**ARLINGTON COUNTY, VIRGINIA  
AGREEMENT No. 20-110-9-6**

**AMENDMENT NUMBER 2**

**Ballston-MU Station Area Improvements Project  
MEMORANDUM OF NEGOTIATIONS**

**CHANGE ORDER No. 4 – Add one (2) new item: Materials Cost Difference for Planter Wooden Benches and Adjust Sanitary Manhole; removing of (6) existing items from Pay Item list.**

1 FLAG SIGN FOOTING - SECTION  
3/4" = 1'-0"

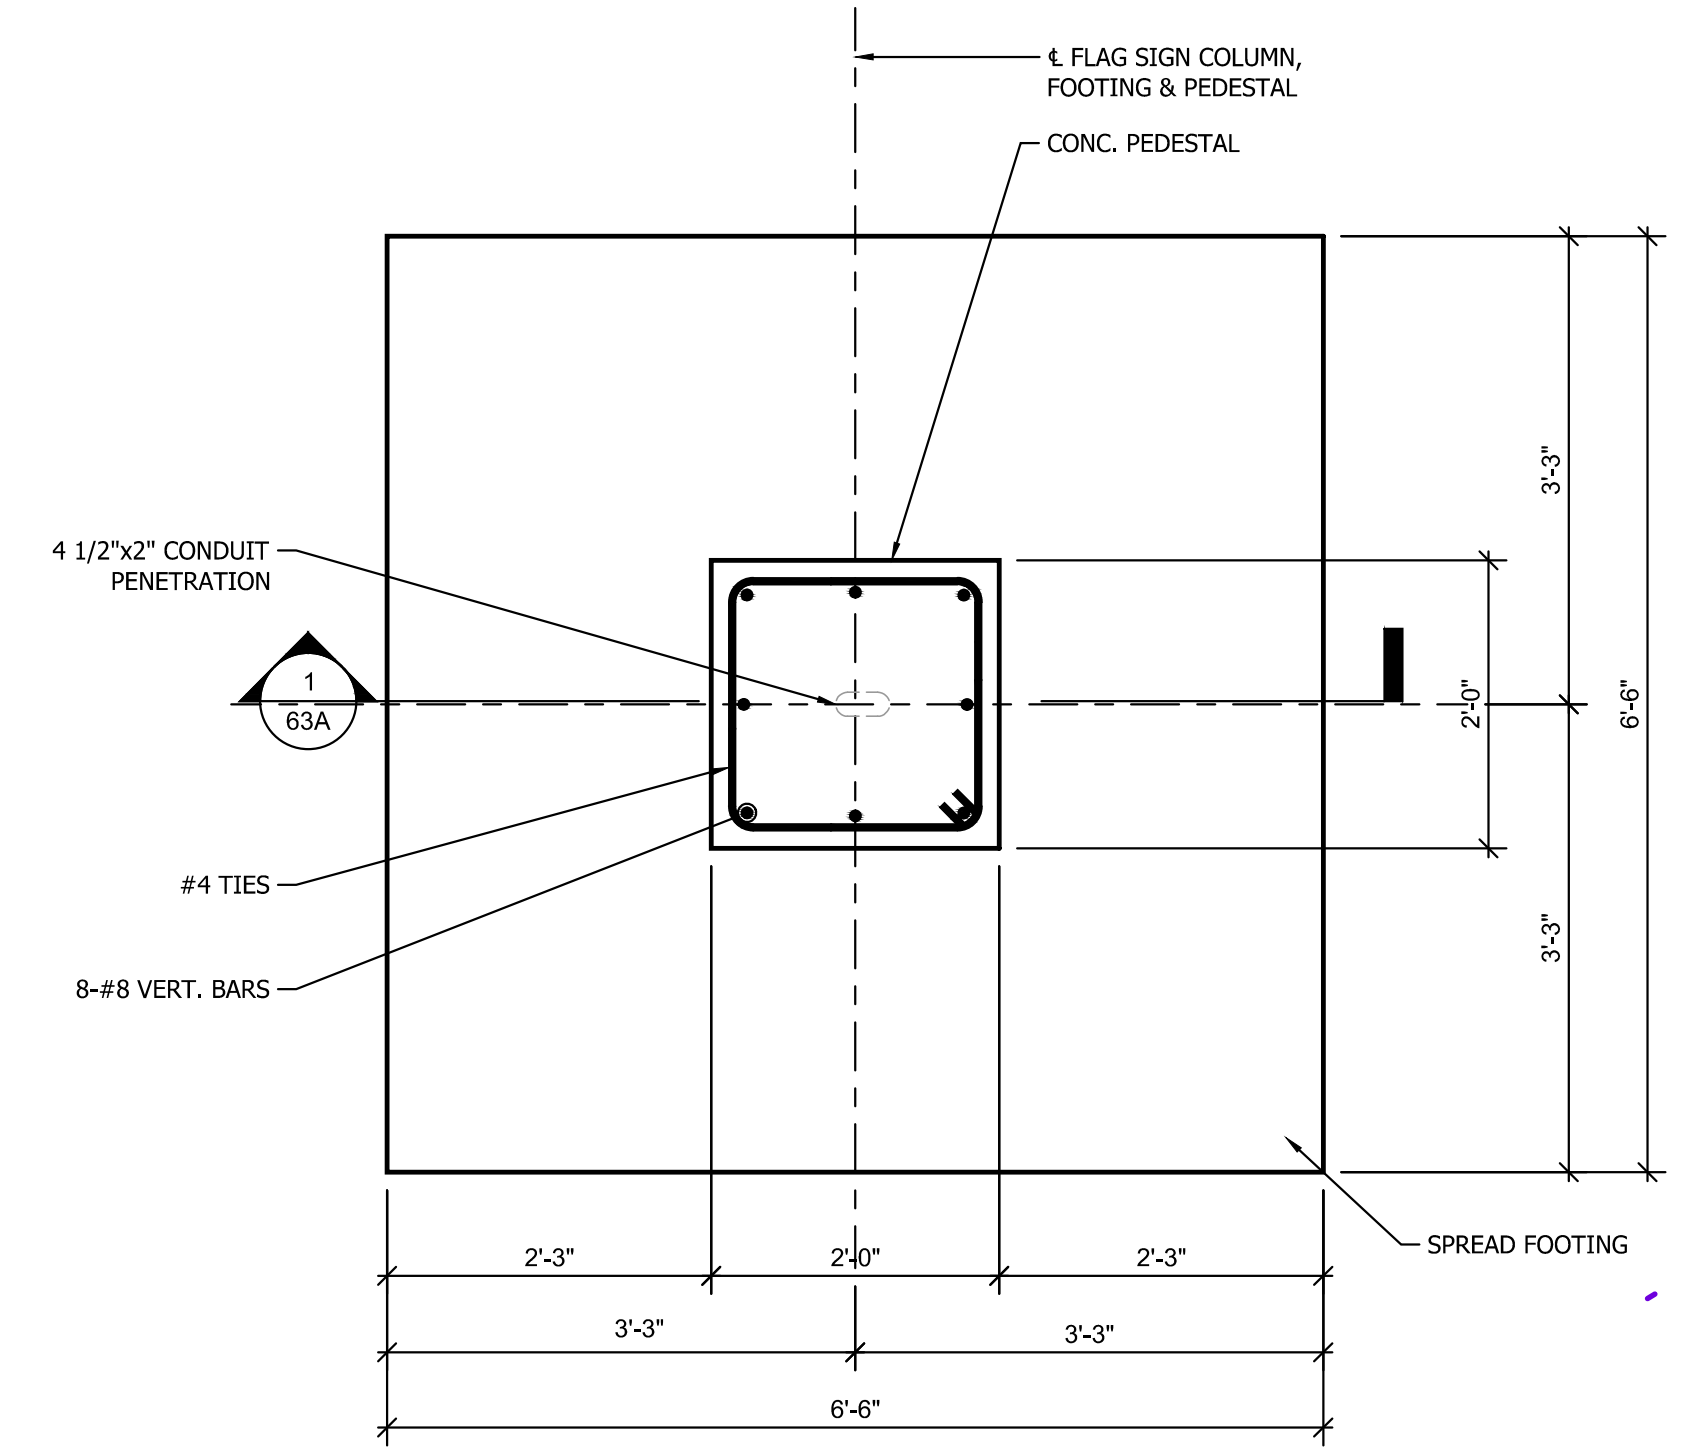
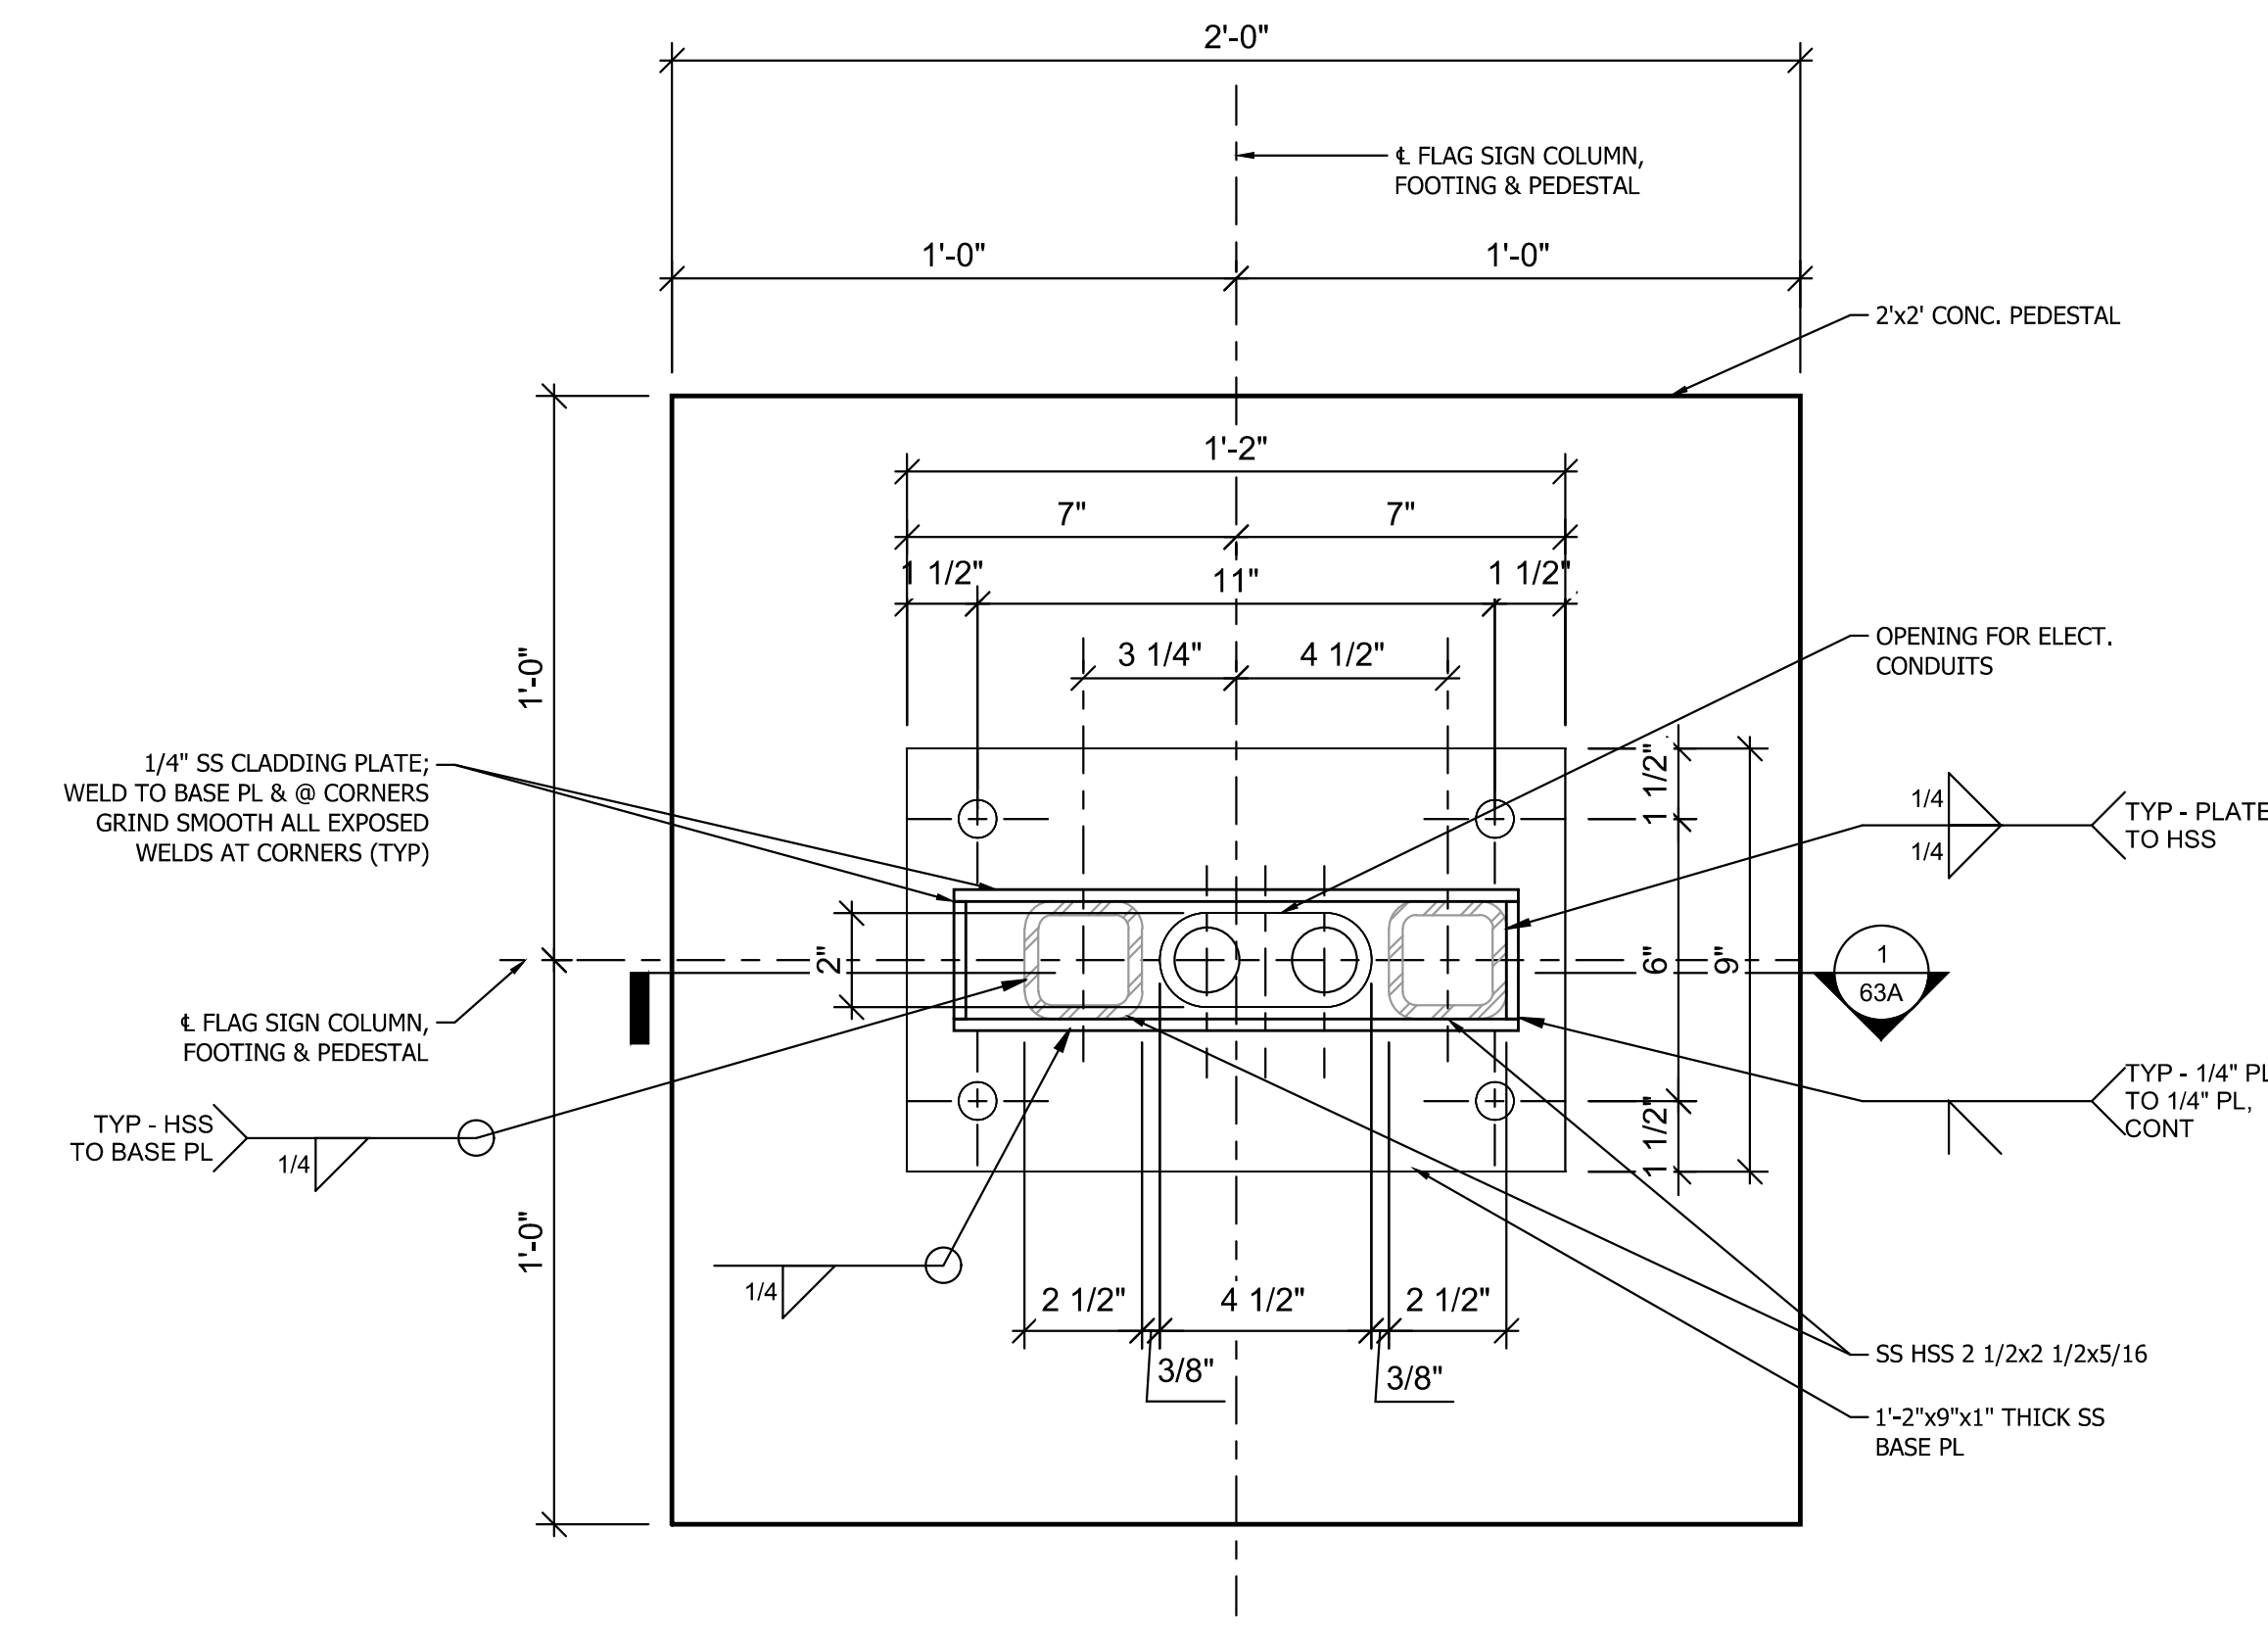
- Reason for Change Order: It was determined that this foundation should use colored concrete due to the NSSR, so a price proposal was requested from Ardent for the difference in cost. In addition, Ardent requested these foundations be paid as a new item to be paid per EA instead of per CY per the bid item for regular foundation.
- Negotiation Recap: Held 09/28/21: Bijay Subedi (PM) and Vivek Thukral (Sr. PM) representing Ardent (Contractor); Alfonso Ronca (PM) and Sekander Salihi (RE) representing Arlington County met virtually and presented each party's estimate for this item: Arlington County Estimate (ACE) = \$398.00 EA; Contractor's Proposal (CP) = \$6,518.00 EA.

Based on these acknowledgements, the parties agreed to add two (2) hrs additional time for labor and equipment to the CP; and to compensate the CP for price difference between colored concrete and regular concrete. As result, the parties arrived at a unit price of \$1,005.00 EA for a total of \$4,020.00 for the 4 spread flag foundations with 1 CD extension of the contract duration.

**Cost Breakdown For Field Modification of Str -1**

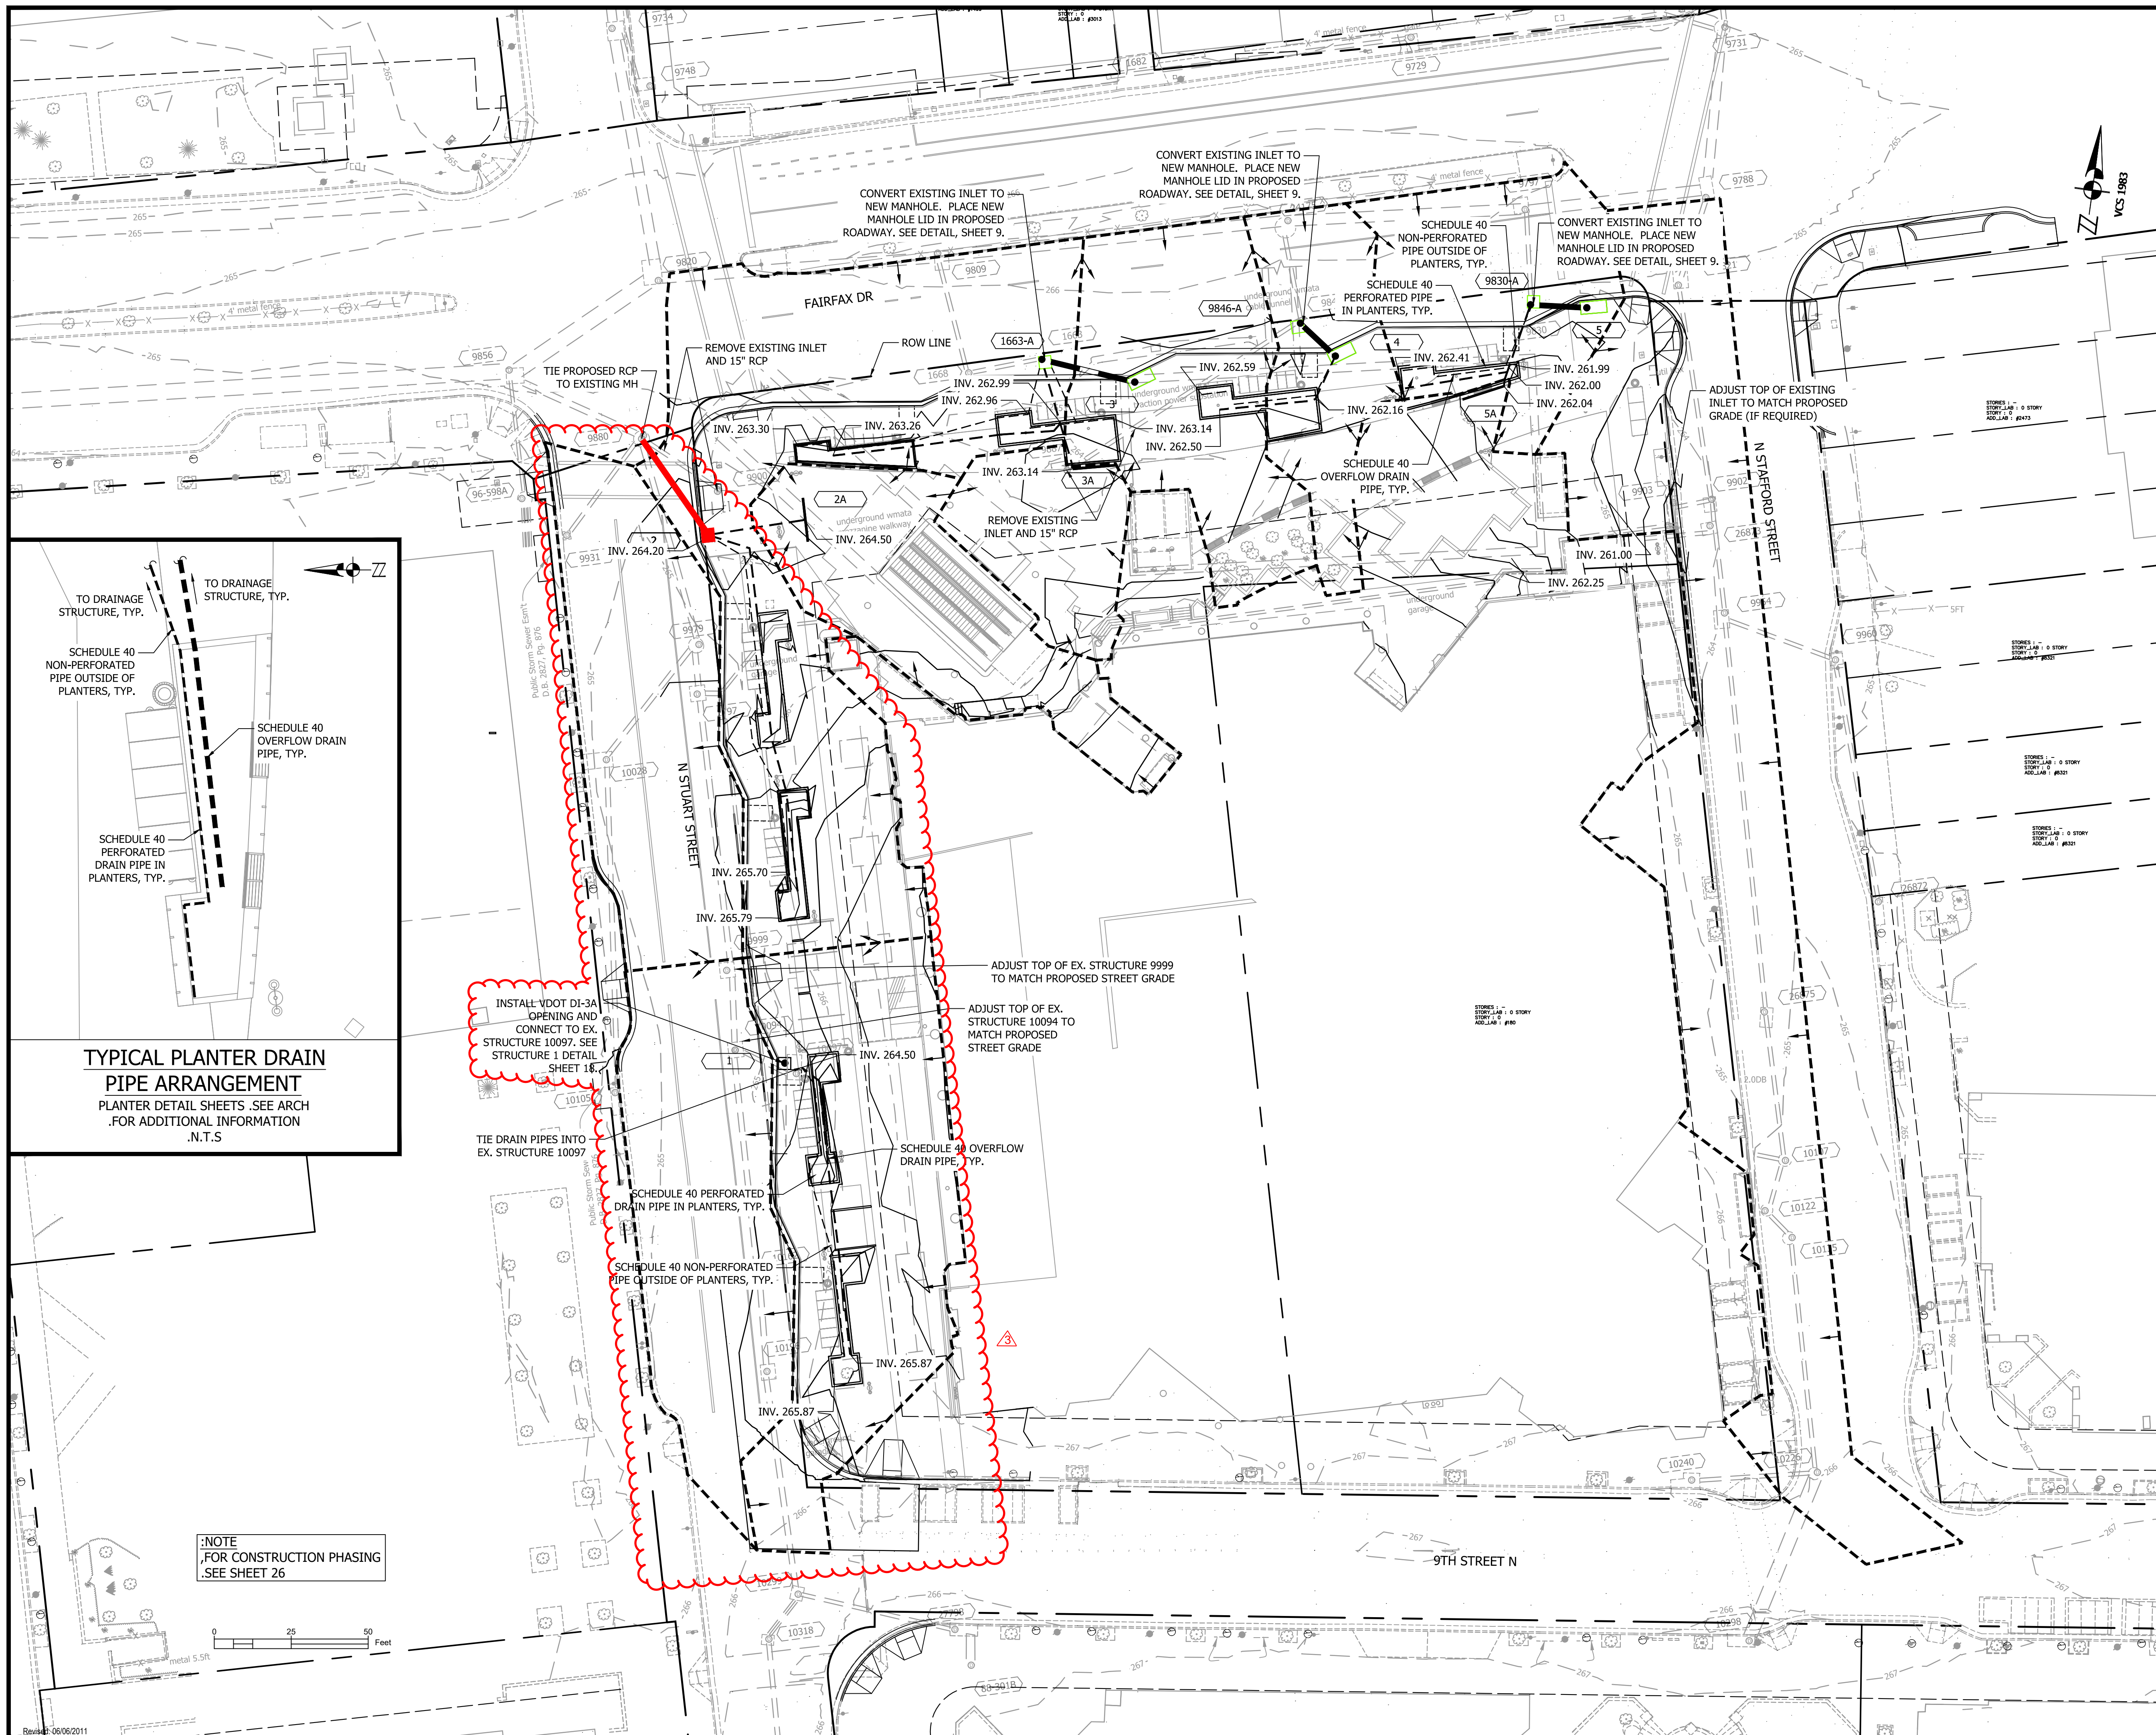
- Reason for Change Order: The NSSR required that this structure (Sheet 18 of 68) to be constructed as part of the Phase 2 SD upgrades be modified to match revised proposed grades, and Ardent was requested to submit a price proposal to perform the work.
- Negotiation Recap: Held 09/28/21: Bijay Subedi (PM) and Vivek Thukral (Sr. PM) representing Ardent (Contractor); Alfonso Ronca (PM) and Sekander Salihi (RE) representing Arlington County met virtually and presented each party's estimate for this item: Arlington County Estimate (ACE) = \$3,921.00 LS; Contractor's Proposal (CP) = \$6,708.00 LS.

Based on these acknowledgements, the CP and ACE agreed: to add 1 service truck to the CP for 16 hrs; to reduce CP backhoe hours to 8, CP skid steer hours to 12, and CP concrete saw hours to 8; and to, the parties agreed that vendor quotes would be used for rebar and frame and cover angle materials. As a result, the parties arrived at a unit price of \$6,425.00 EA.
